City of Portland
CRC Design Refinements
Flexible Service Work Order

DRAFT FINAL
FINDINGS REPORT

July 7, 2010

Work Order No. 36670-1

Figure S-2
Southbound A.M.
Speed Profiles
in 2030

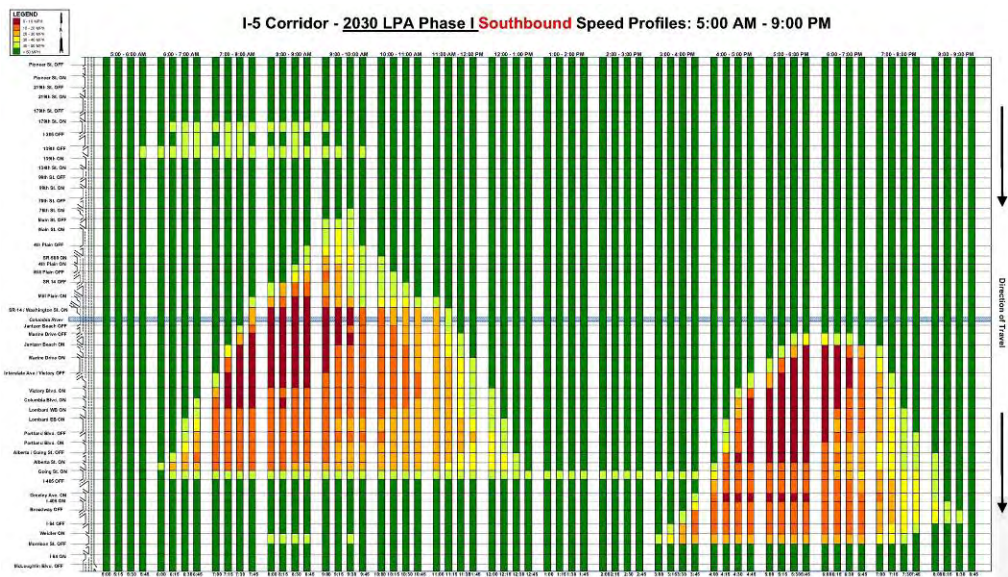
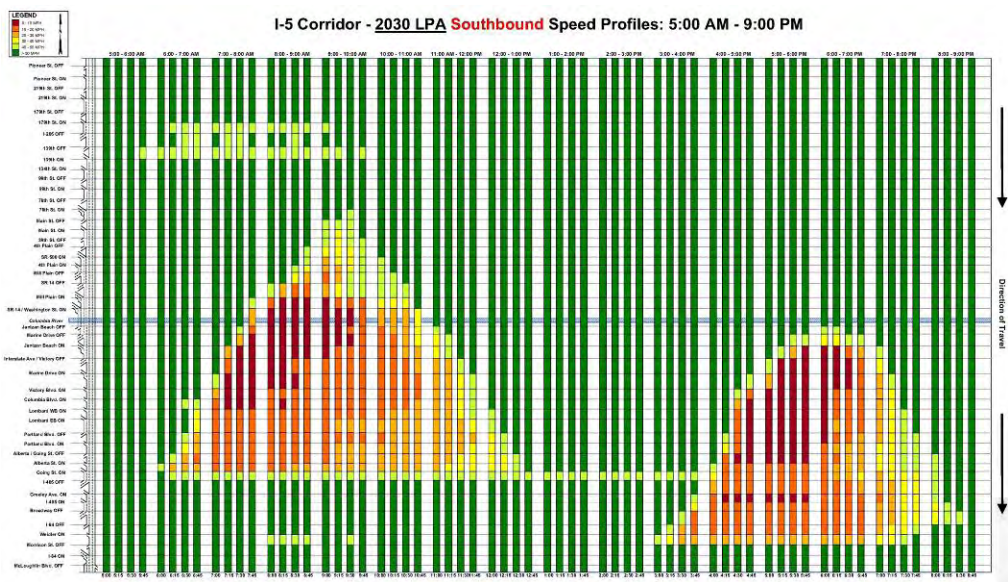
A comparison of the speed profiles for the A.M. peak period southbound for the No-Build, the 10-lane and the 12-lane alternatives is provided on page 5. A detailed explanation of the speed profile diagrams is contained in the CRC Draft Traffic Technical Report, March 2010.

- Backups on I-5 south of the CRC project area will negatively affect I-5 A.M. peak southbound performance in the CRC project area in 2030 (CRC VISSIM speed profile analysis shows speeds of less than 20 mph in the project area); this backup condition also masks, in the speed profile diagrams, the performance of the 10- and 12- lane bridges in the project area.
- There are no appreciable differences visible in the speed profiles between the CRC 12-lane proposal and the 10-lane proposal; both show significant improvements over the performance of the No-Build alternative.

Figure 1
Schematic Lane Drop at Hayden Island for
Northbound Scenario 2

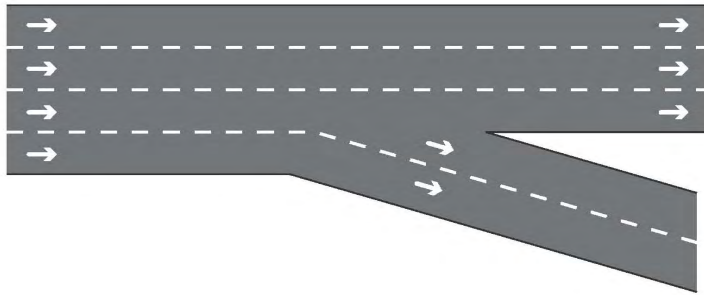
Northbound (NB) Scenario 2: Drop the NB Auxiliary Lane from Victory Boulevard at Hayden Island Exit

This concept was developed in response to the City’s desire to explore alternative ways of reducing auxiliary lanes as I-5 approaches the bridge. In this scenario, the northbound entrance from Victory Boulevard would be carried along I-5 as an auxiliary lane but unlike LPA Phase 1, it would be dropped at Hayden Island (Ramp 5N-HI), as indicated in **Figure 1**. I-5 would continue as three lanes toward the northbound entrance from Marine Drive, which would join the mainline as an auxiliary lane. These four lanes would then be joined by a fifth lane, the northbound entrance from Hayden Island. Exhibit A in **Appendix B** depicts the detail at this entrance location. Lane 5 would be carried as an auxiliary lane to the Mill Plain exit where it would be dropped. This would yield a configuration of five northbound lanes over the bridge. The overall lane configuration for NB Scenario 2 is shown in **Figure 2**.

2. North of the exit to Hayden Island, I-5 would contain four lanes under NB Scenario 1 and three lanes under NB Scenario 2. This reduced mainline capacity under NB Scenario 2 would need to be evaluated in the CRC traffic model to determine whether it is a critical constraint.

- NB Scenario 2 could result in improved operations over NB Scenario 1 by virtue of the continuous flow of Hayden Island traffic as it enters the freeway. Further traffic modeling analysis would be needed to confirm this potential benefit and, accordingly, whether NB Scenario 2 should be retained for further design development.

Figure 2
Lane Diagram for
Northbound Scenario 2

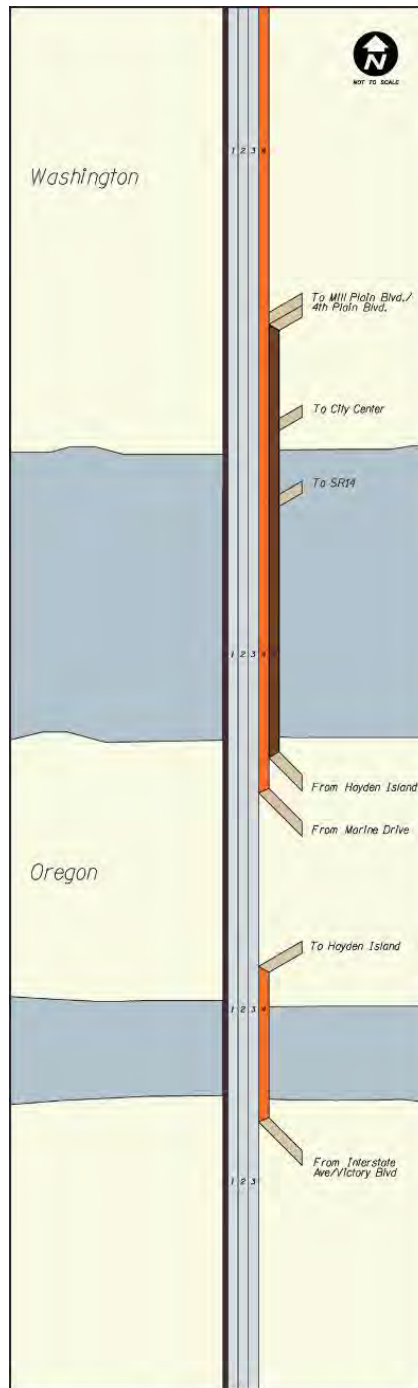
1. Under NB Scenario 2, Hayden Island traffic would join I-5 as an auxiliary lane without merging into the mainline. This is a feature in common with the CRC LPA Full Build. Furthermore, NB Scenario

2 would carry this auxiliary lane to Mill Plain Blvd. instead of SR 14 as would be the case under the CRC Full Build configuration. This would increase available lane-change distance for Hayden Island traffic by about 1700 feet.

Figure 3
Schematic Lane Drop Prior to CD Merge
for Southbound Scenario 2

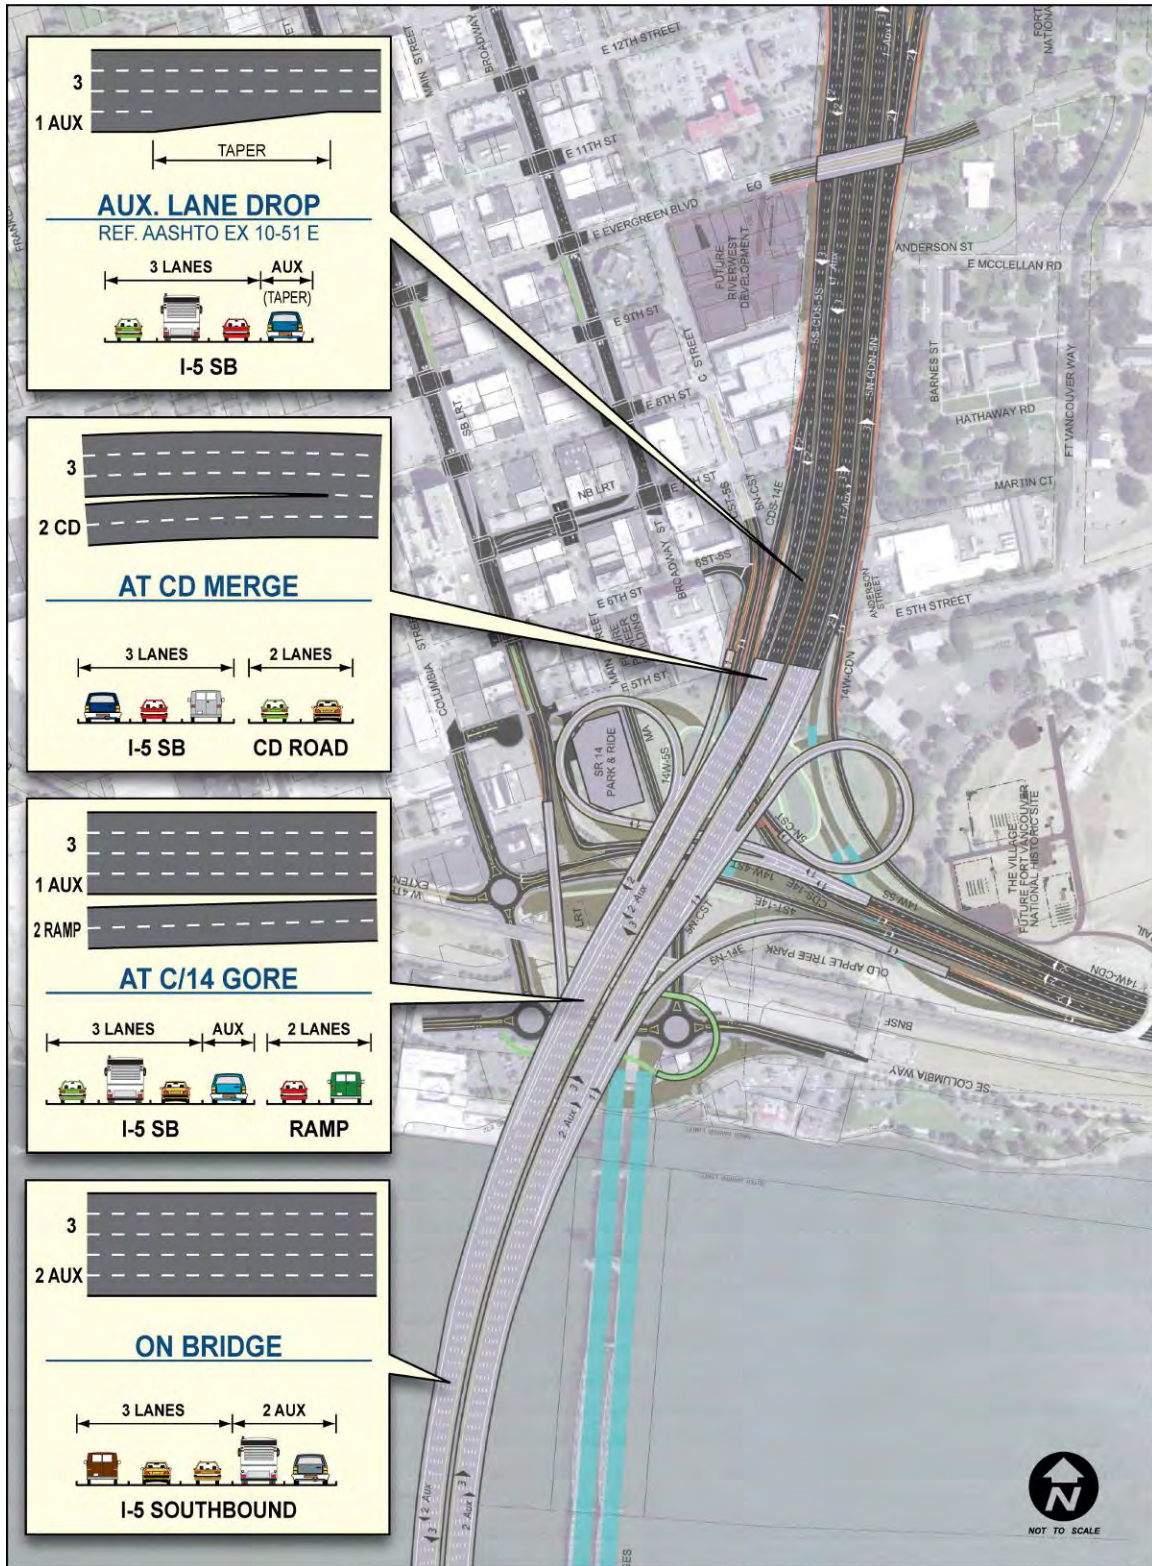
2. The Lane 4 auxiliary lane drop proposed under SB Scenario 2 would be the trade-off for the SR 14 auxiliary lane on the bridge. I-5 traffic in Lane 4 would need to maneuver left approaching the tapered merge. However, the distance available for this maneuver and advance signing would begin downstream from the SR 500 entrance.

This concept is illustrated in **Figure 3** below. The AASHTO guideline (Exhibit 10-51 and related text) for merging the SR 500 auxiliary lane is also included as **Figure 4**.

- SB Scenario 2 could result in improved operations over SB Scenario 1 by virtue of the continuous flow of SR 14 traffic as it enters the freeway. Further analysis is underway by CRC project staff to confirm this potential benefit and accordingly, whether NB Scenario 2 merits further consideration for design development.

Figure 7
 CRC LPA Phase 1: 10-Lane Design
 (5 Lanes Southbound Across Columbia River)

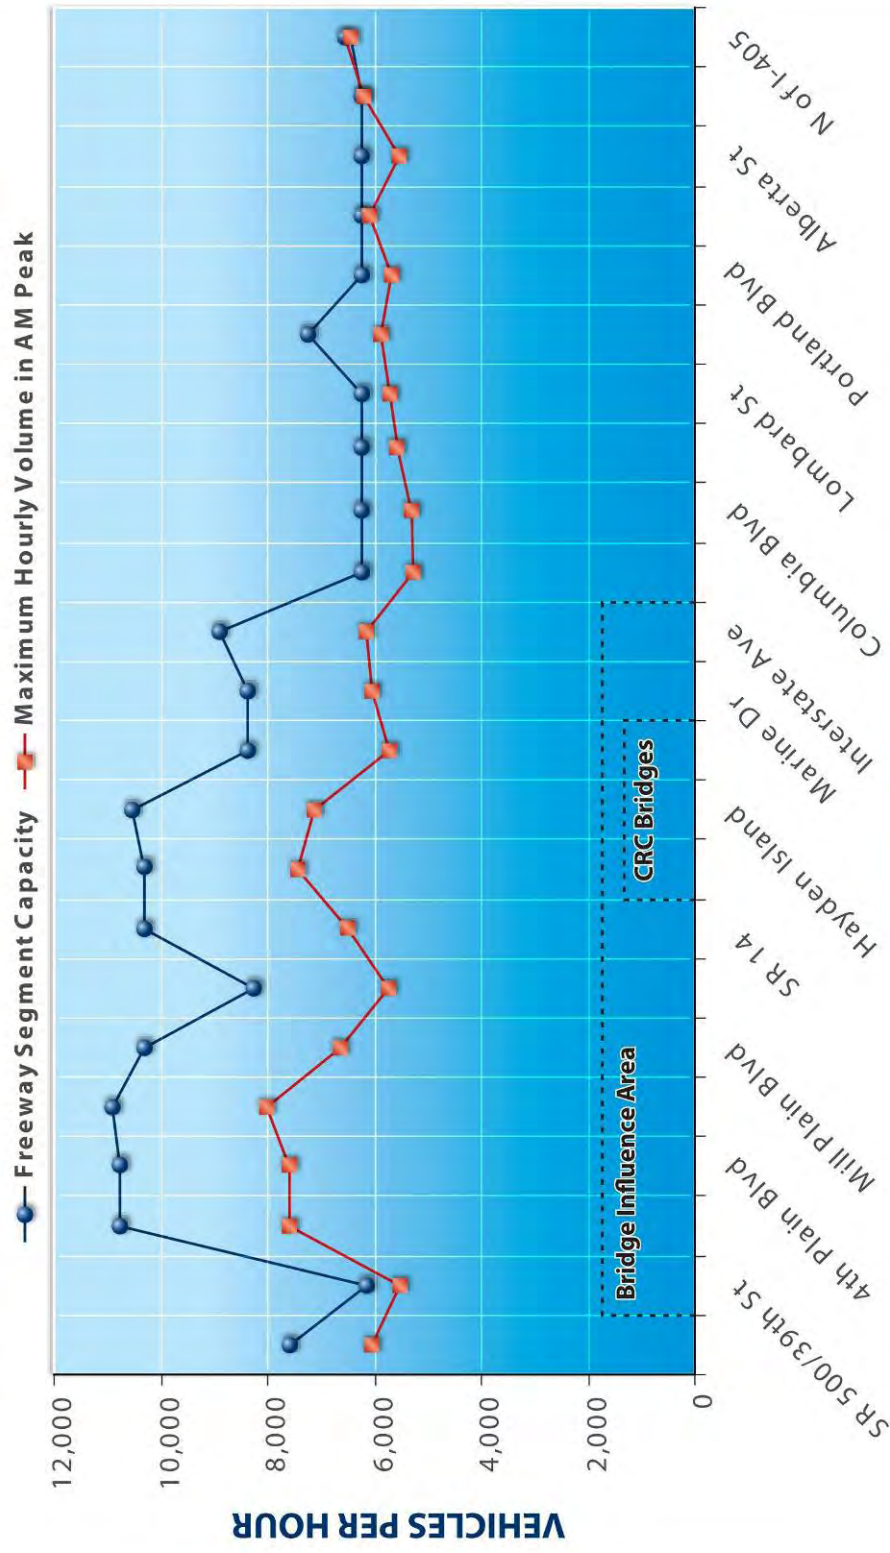
Figure 7, Maximum Hourly Volume vs. Capacity, illustrates the forecast 2030 A.M. traffic demand and estimated capacity in terms of passenger cars per hour on I-5 southbound from SR 500 to the I-5/I-405 split. On this diagram the red line indicates maximum hourly volumes in the A.M. peak hour and the blue line represents freeway segment capacities estimated by URS according to guidance provided in the

With respect to weaving, the HCM 2000 specifies reduced capacities for weaving segments less than 2,500 feet in length. For the initial analysis, we assumed that only the location south of Going Street contains a weave less than 2,500 feet. For this Findings Report, the figure has been updated to include weaving considerations in the southbound direction.

- I-5 southbound north of the I-405 split is identified as a bottleneck location with at-capacity traffic demand within a weaving area, under both No-Build and LPA conditions. The segment on I-5 southbound from Going Street on-ramp to I-405 off-ramp is a Type C weaving area (one weaving maneuver requires at least two lane changes) according to HCM 2000. As illustrated in **Figure 7**, with LPA built the forecast traffic demand on I-5 southbound between Going Street and I-405 is very close to the estimated capacity.

Figure 8
Cross Sections of Existing
CRC Refinement LPA Phase 1 and LPA Full Build
(10- and 12-lane bi-level main spans)

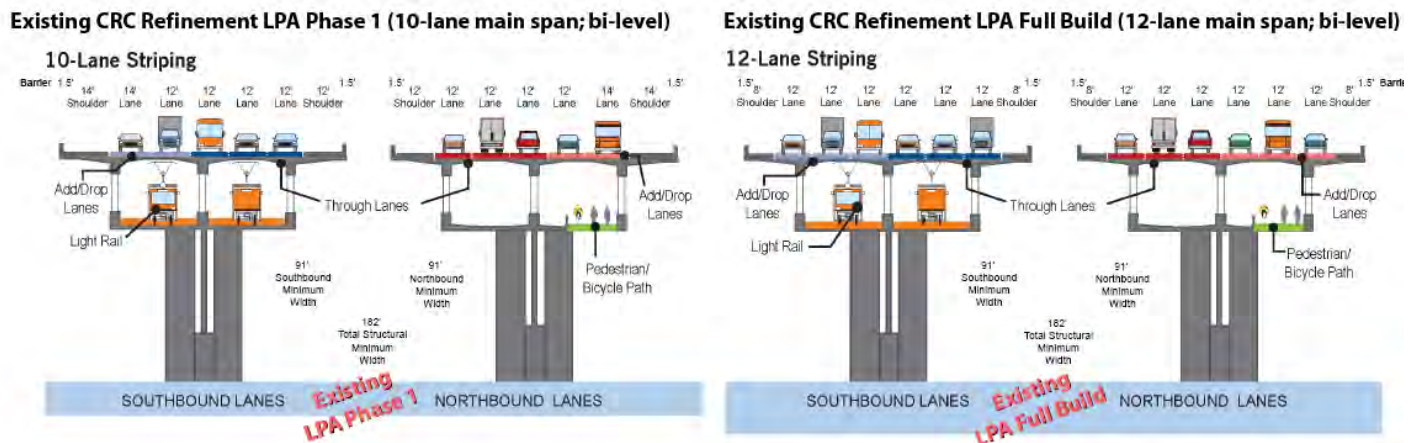
The 12-lane, bi-level facility proposed by CRC is shown below in **Figure 8**. The nominal width of each deck is 88 feet that would be striped initially for a 10-lane facility with four 12’ lanes, one 14’ lane, a 12’ inside shoulder and a 14’ outside shoulder on each deck. Each bridge would be restriped in the future to a 12-lane facility with six 12’ lanes and two 8’ shoulders.

There are ramp tapers on the river crossing structure that increase these nominal widths. Based on information provided by CRC, the upper deck area for the 12-lane Columbia River Crossing bridge with this arrangement is 557,700 square feet.

The Phase 1 LPA 10-lane facility proposed by CRC is “overbuilt” to provide the flexibility of future restriping to a future permanent 12-lane facility. A refinement of this option could be to provide an initial 10-lane facility that does not allow future restriping to 12 lanes. This arrangement is shown below as the CoP 10-lane permanent main span, and represents a 4’ width savings for each deck as compared to the proposed CRC Phase 1 LPA 10-lane section. A further refinement would be to provide an 8-lane facility, also shown

Figure 9
Cross Sections of
City of Portland Refinement Options
(8- and 10-lane bi-level main spans)

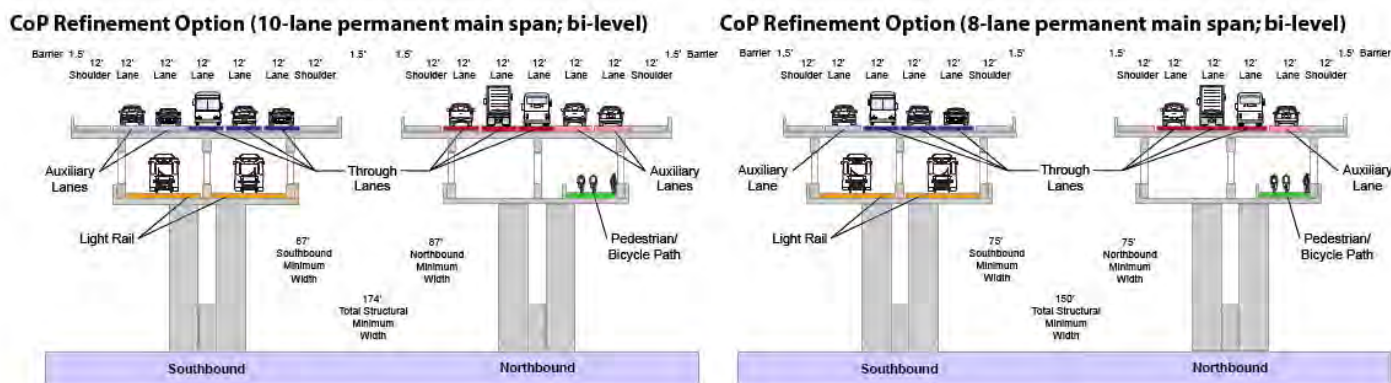
below. The 8-lane facility would represent an additional 12' width reduction for each deck from the CoP proposed permanent 10-lane section. These refinement options are shown in Figure 9.

The table below summarizes the potential bridge cost savings of these refinements. The bridge cost includes both the savings for the river crossing bridge and the approach bridges on each side of the river. There would also be additional roadway and interchange related savings, which are not addressed here.

Figure 12
Cross Section of
City of Portland Refinement Option
(10-lane bi-level main span, single structure)

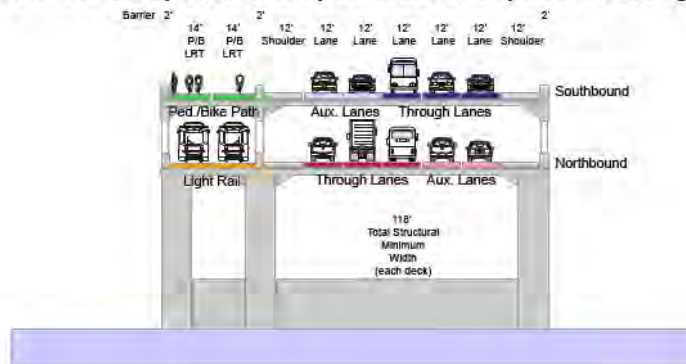
Other lane configurations, such as the arrangement shown in **Figure 12**, have been suggested that accommodate all of the traffic components on a single structure. Although possible, it is not expected that this type of arrangement would be structurally economical. Large transverse spans are required to accommodate the 5-lane traffic arrangement and the unsymmetrical longitudinal supporting members would not lead to an economical design.
